January 2025

The proposed changes to the Policies Map are comprised of range of amendments, corrections and additions to the mapping information that forms part of and supports the new Local Plan.

The following table sets out the proposed changes to the Policies Map for the new Lewisham Local Plan. The table is published to allow those with an interest in the new Local Plan to comment on the proposed changes to the Policies Map (alone).

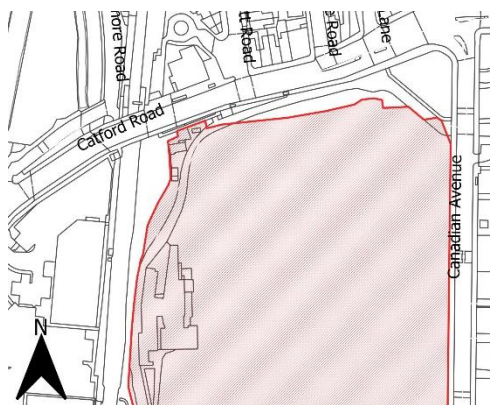
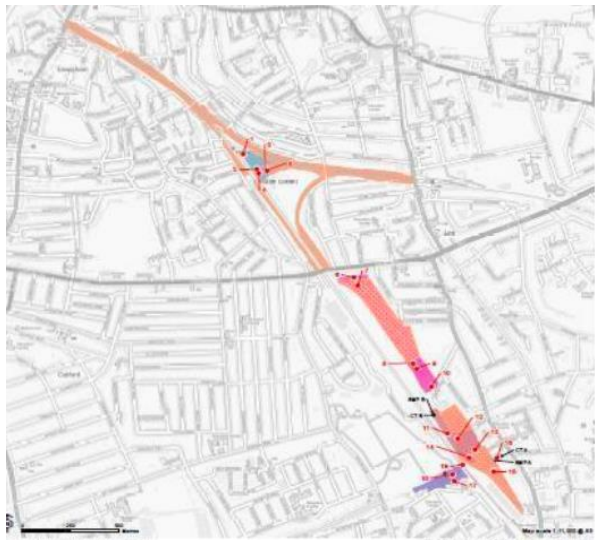
Change Reference	Local Plan Policy Reference	Proposed Change to Submission Policies Map (PCSPM)	Reason for Change
Part Two – Managing Development			
Chapter 5 – High Quality Design			
PCSPM1	Policy QD4 Figure 5.6	<p>QD4 Building heights</p> <p>Figure 5.6: Catford tall building suitability zone</p> <p>Appropriate location for tall buildings – amend boundary for Laurence House to exclude overflow car park.</p> <p>Existing:</p>  <p>Proposed:</p> 	Modifications to provide clarity and reflect evidence. Namely, the removal of Laurence House overflow car park from the tall building suitability zone. (AP136)

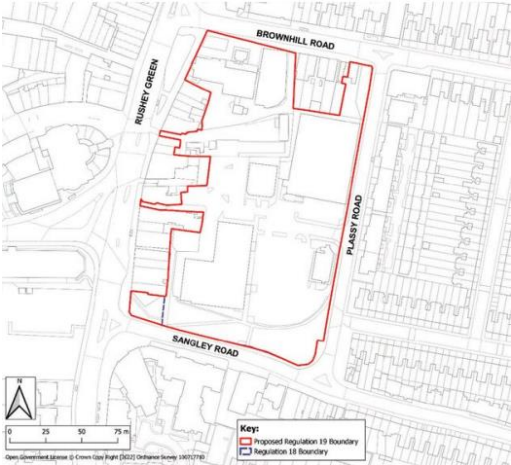
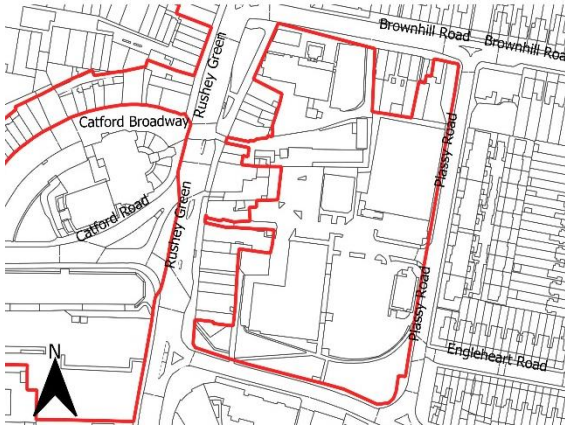
PCSPM2	Policy QD4 Figure 5.8	<p>QD4 Building heights</p> <p>Figure 5.8: Bellingham tall building suitability zone</p> <p>Appropriate Location for tall buildings – amend boundary to remove part the land west of Culverley Green Conservation Area.</p> <p>Existing:</p>  <p>Proposed:</p> 	Modifications to provide clarity and reflect evidence. Namely, an amendment to the extent of the tall building suitability zone to take account of the adjoining Culverley Green Conservation Area. (AP138)
Chapter 6 – Heritage			
PCSPM3	Policy HE2	<p>HE2 Designated heritage assets</p> <p>Somerset Gardens London Square</p> <p>Proposed:</p> 	Modification to identify previously omitted London Square. (AP85)

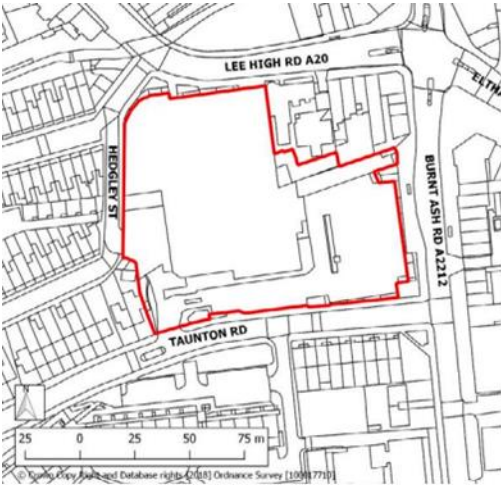
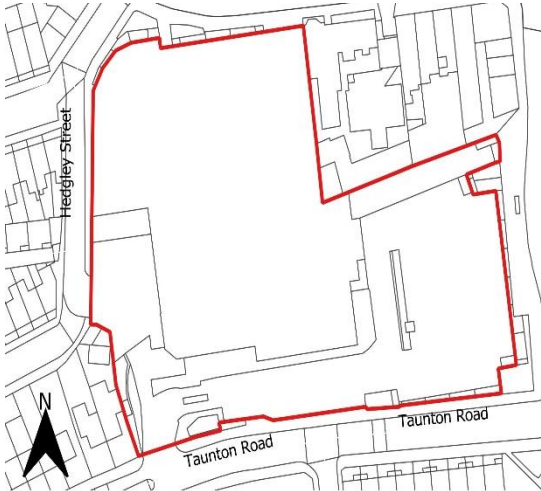
PCSPM4	Policy HE2	<p>HE2 Designated heritage assets</p> <p>Lewisham High Street (East) London Square</p> <p>Proposed:</p> 	<p>Modification to identify previously omitted London Square. (AP85)</p>
Chapter 8 – Economy and Culture			
PCSPM5	<p>Policy EC5</p> <p>Figure 14.2</p>	<p>EC5 Strategic Industrial Locations (SIL)</p> <p>Figure 14.2: Central Area key diagram</p> <p>Bromley Road Strategic Industrial Location – boundary amendment to include 4 and 4a Randlesdown Road.</p> <p>Existing:</p>  <p>Proposed:</p> 	<p>Modification to amend the boundary of the Bromley Road SIL and Local Centre; the SIL boundary should include 4 Randlesdown Road whilst the row of retail units/takeaways should lie outside of the SIL boundary.</p> <p>*NB – the amended boundary is located in the southeast corner of the SIL.</p>
